Architectural Review Board Staff Report

Project Type: Amended Site Development Section Plan

Location: River Crossings, Lot 1 (Villa Farotto's)

Description: **River Crossings, Lot 1 (Villa Farotto's)**: An Amended Site Development Section Plan, Architectural Elevations, and Architect's Statement of Design for a 1.985 acre tract of land zoned "PC" Planned Commercial located northeast of the intersection of Chesterfield Airport Rd. and Arnage Blvd.

COMMERCIAL GRADE LIGHT STRING

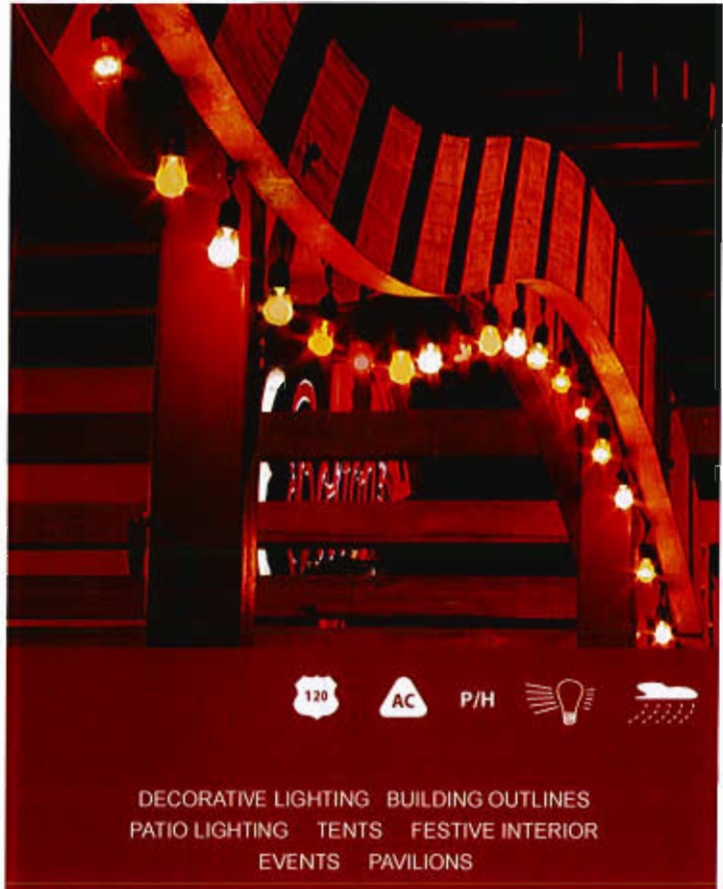
Proposed lighting involves low-level string lighting which will accent the patio area. A lighting detail has been submitted (see packet) with additional information on the proposed lighting. The City of Chesterfield Lighting Ordinance would permit this accent lighting with review and approval by the Planning Commission.
